CONSOLIDATED EDISON COMPANY OF NEW YORK, INC.
(Indian Point Nuclear Generating Unit No. 2)

Docket No. 50-247

CONSOLIDATED EDISON COMPANY, INDIAN POINT NO. 2 (IP-2)
DOCKET NO. 50-247
CONTAINMENT BUILDING REINFORCEMENT BAR PLACEMENT

SUBJECT Westinghouse Electric Corporation
Indian Point Generating Station - Unit No. 2
Temporary Opening North Face
Containment Building

SECT. C-C TEMP.
OPNG @ -7'
V/C #2 SCALE ½"=1'
DR. 4/28/70

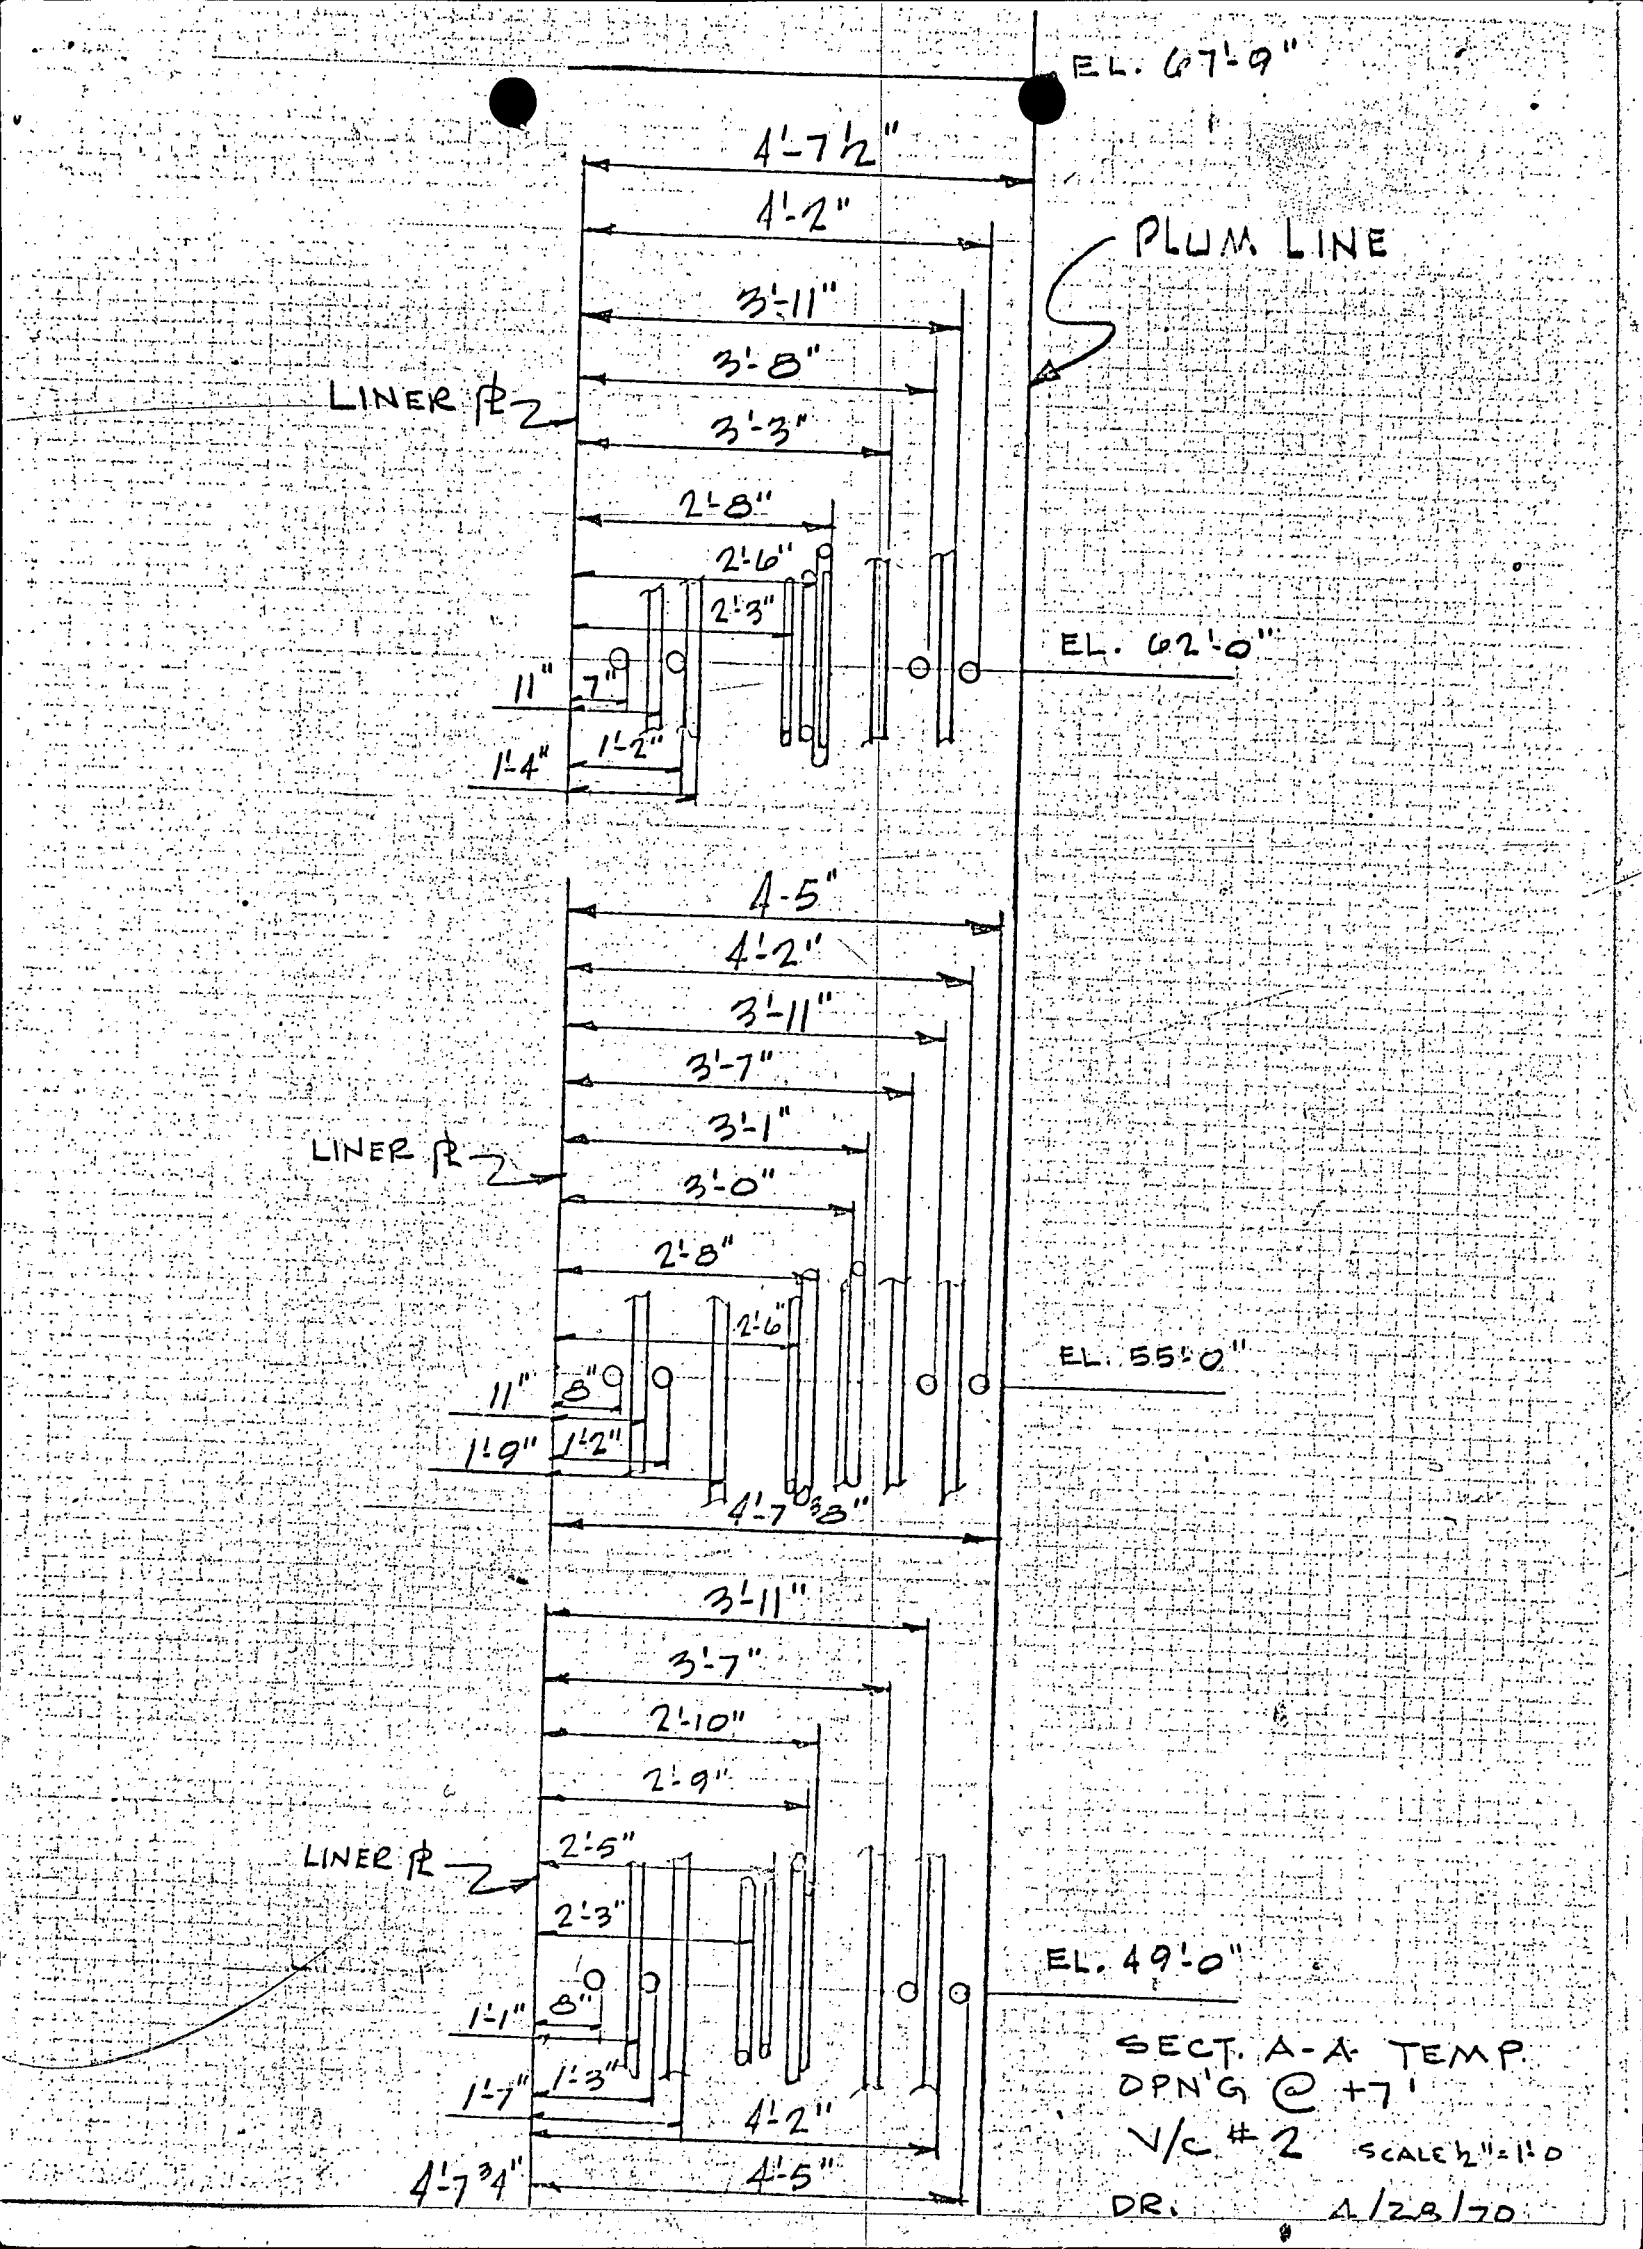
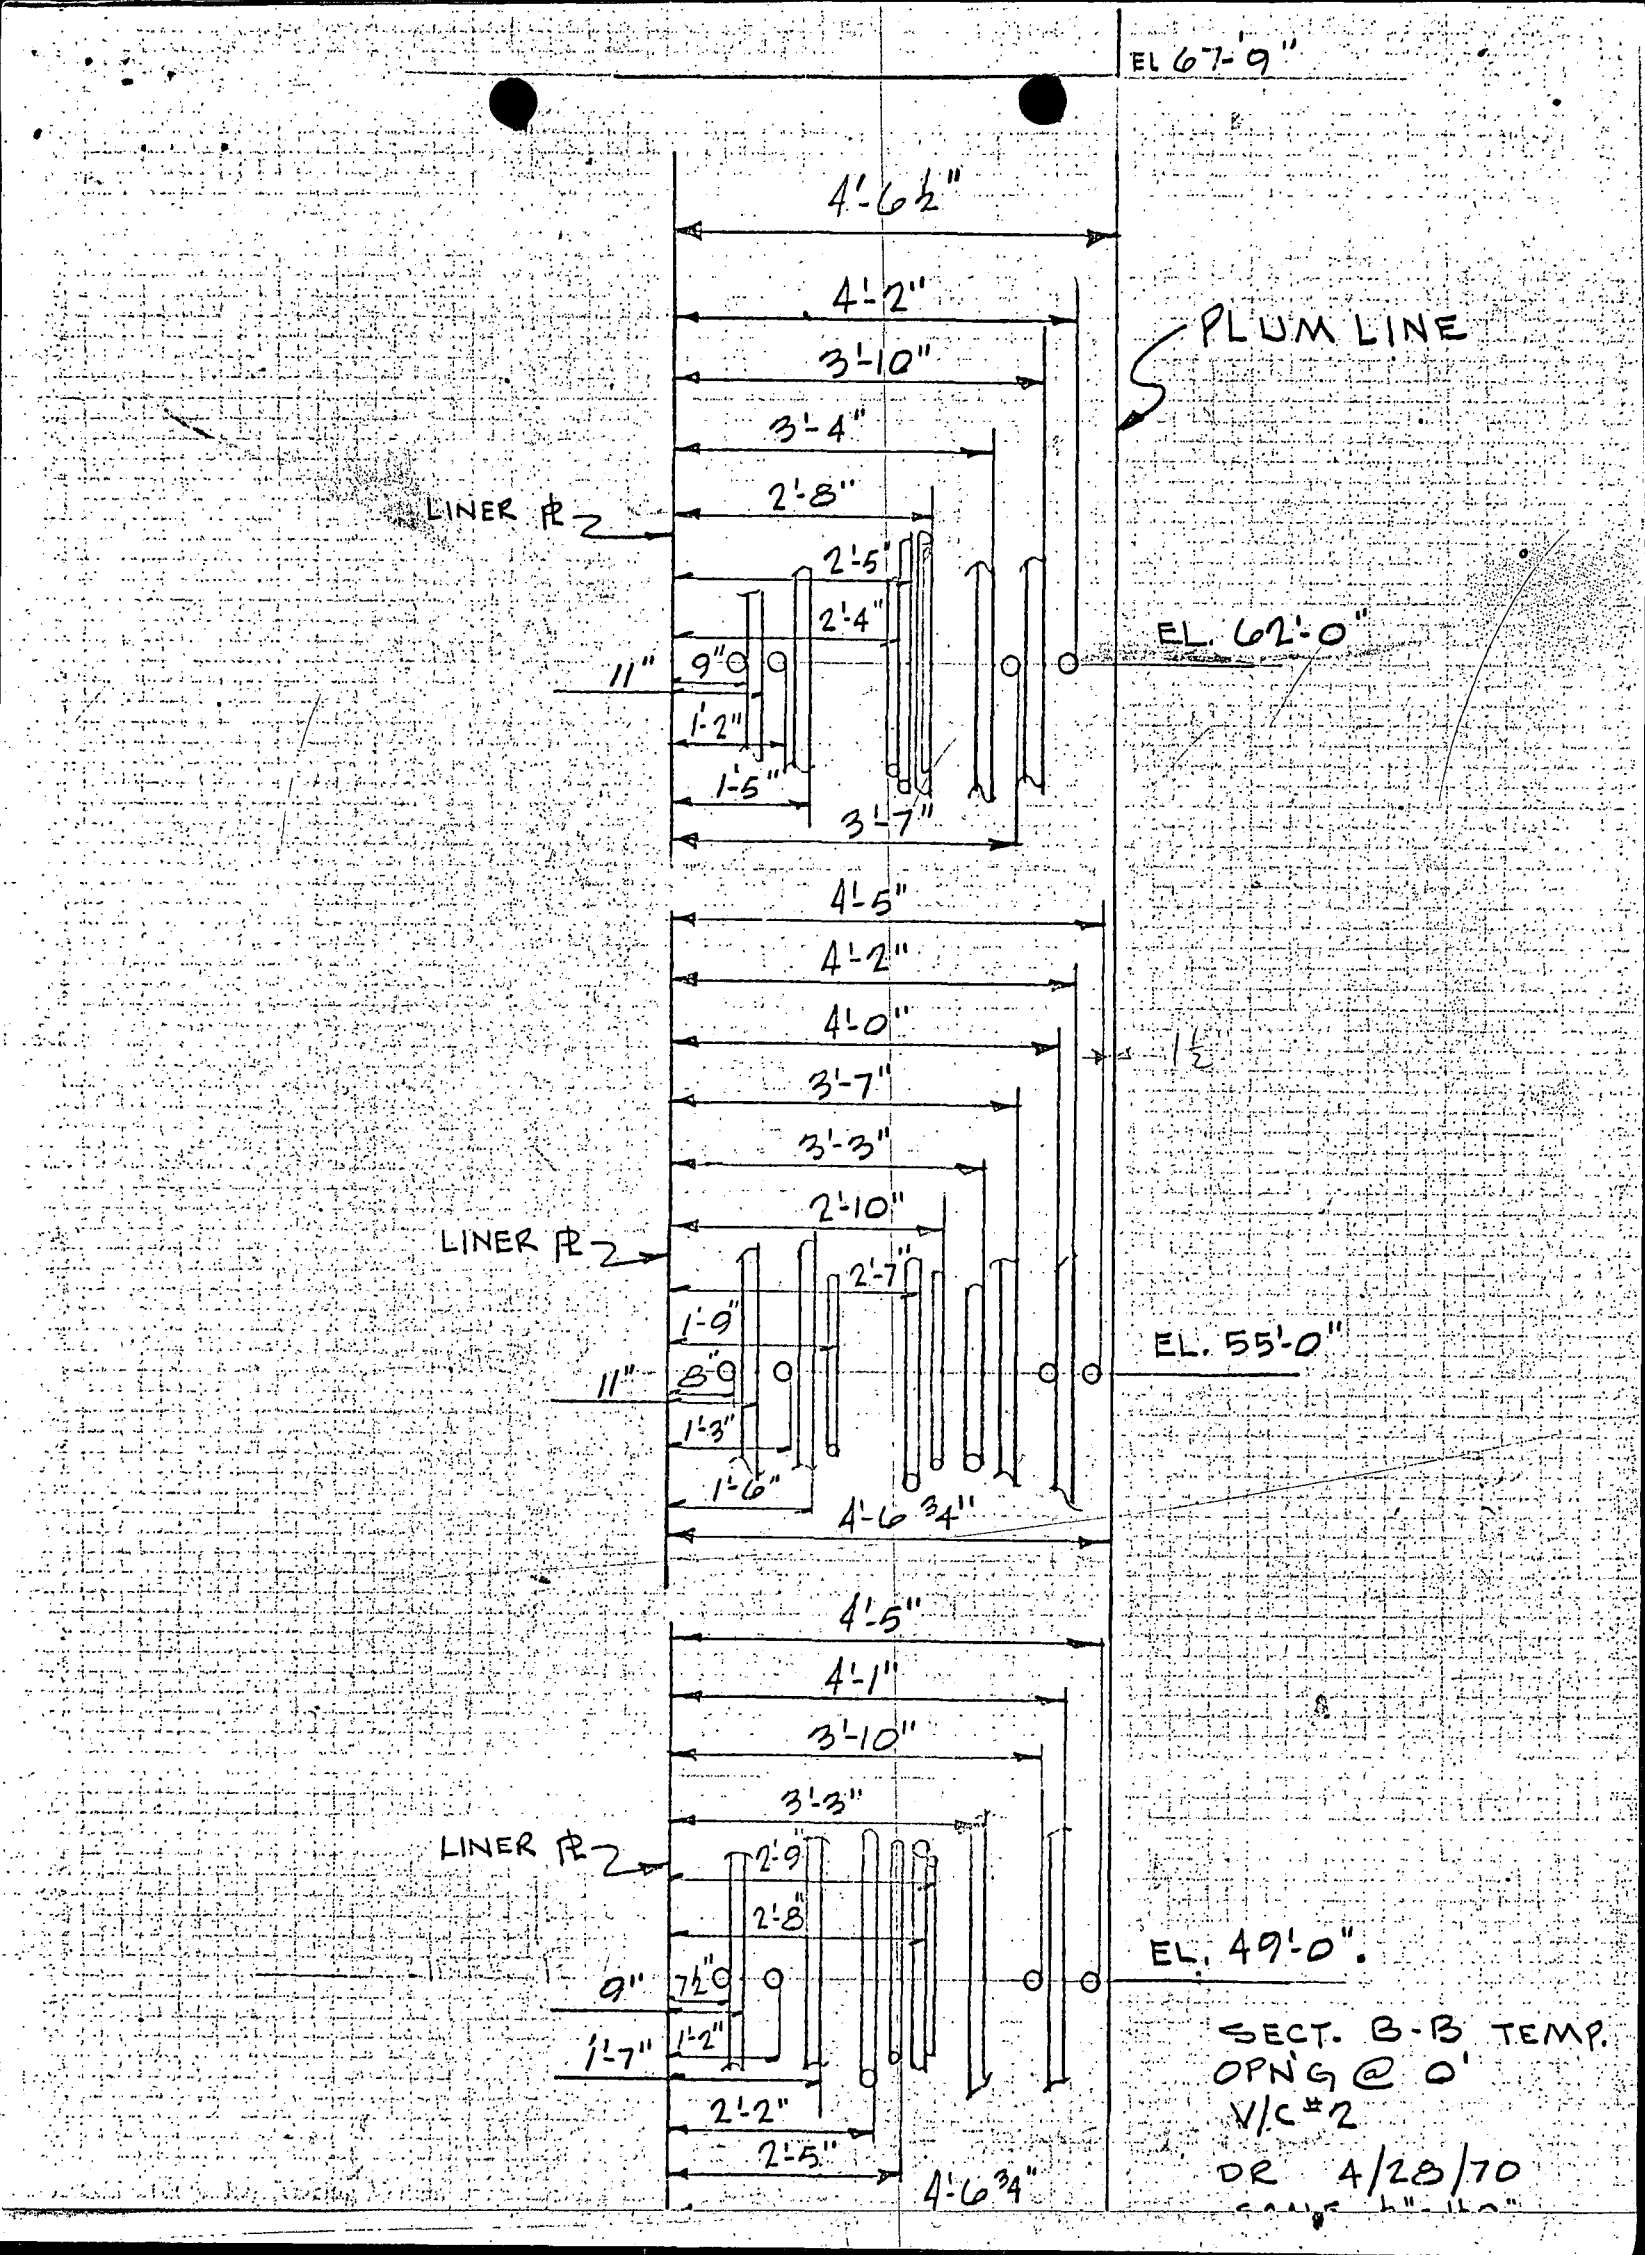
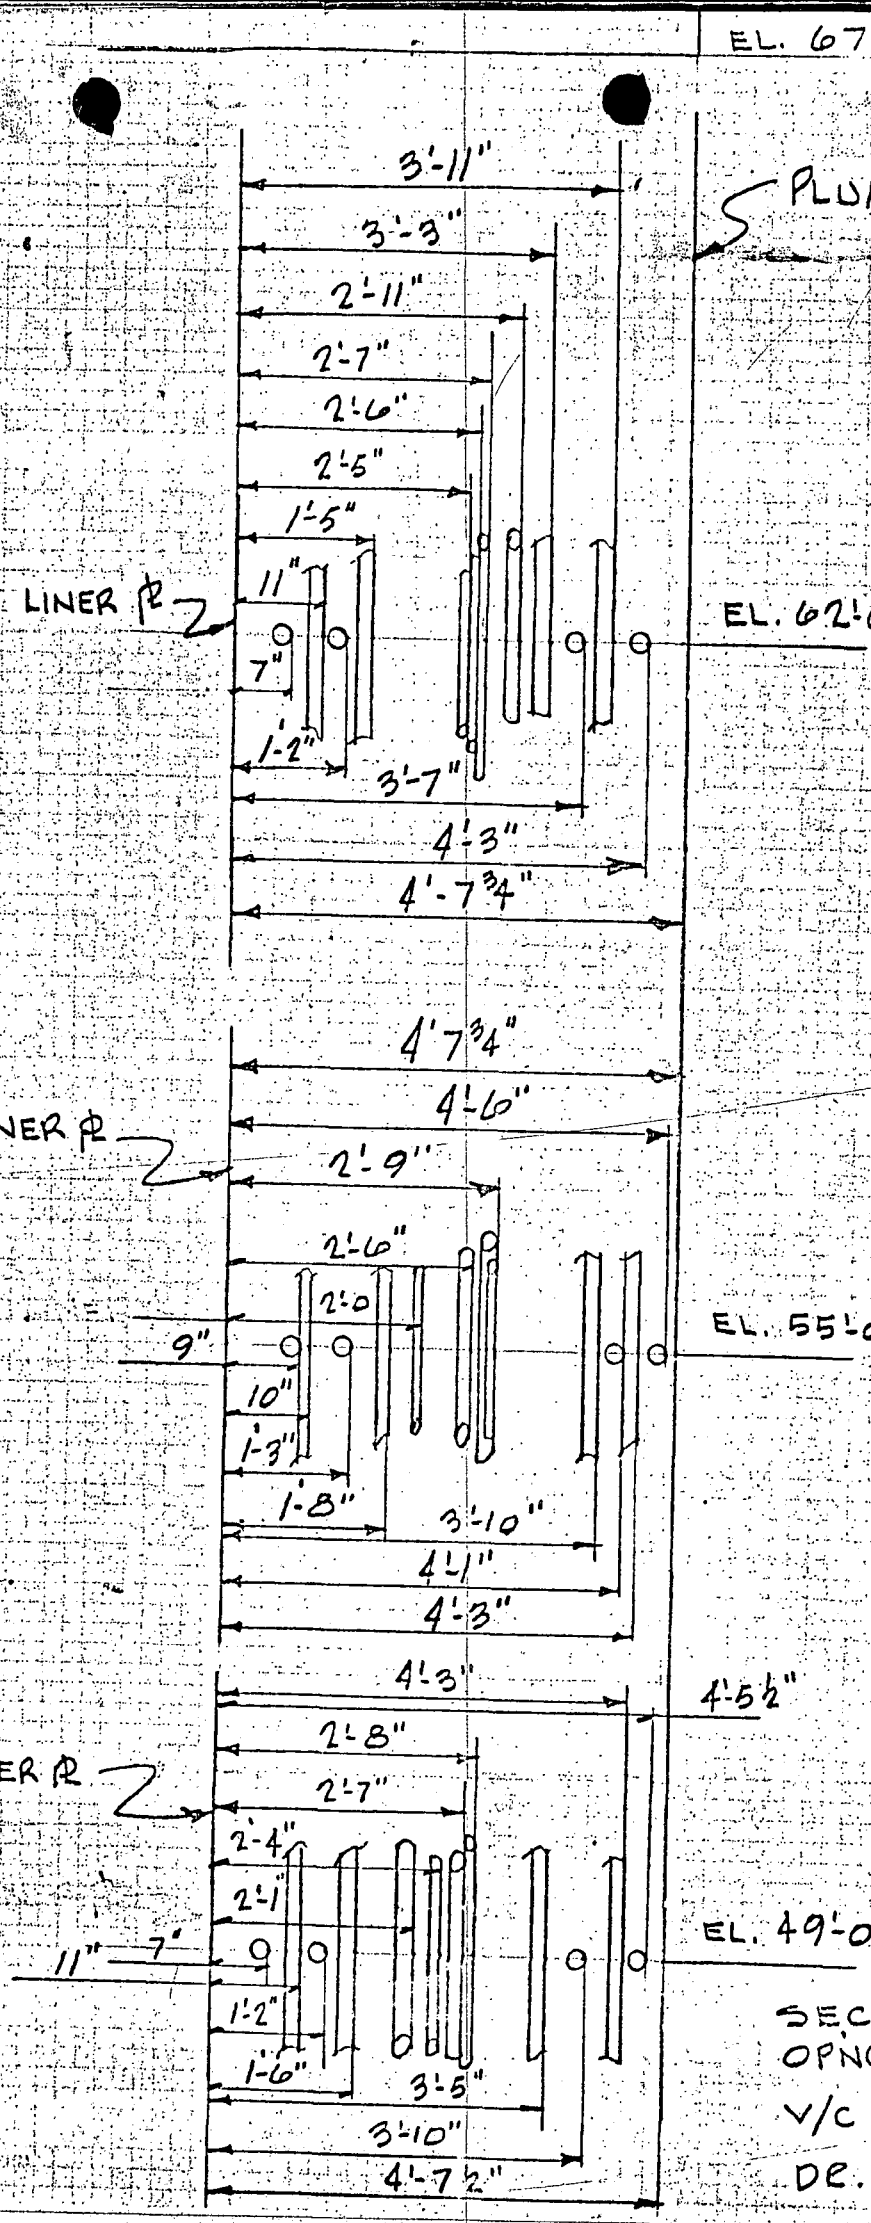
There is not much to be concerned about so far as the stagger of the cadweld's is concerned. It would have been better construction practice to increase the spacing. The major concern is that there is insufficient concrete cover over the splices. This cover should vary from 1½" to 3" depending on the use and environmental exposure.
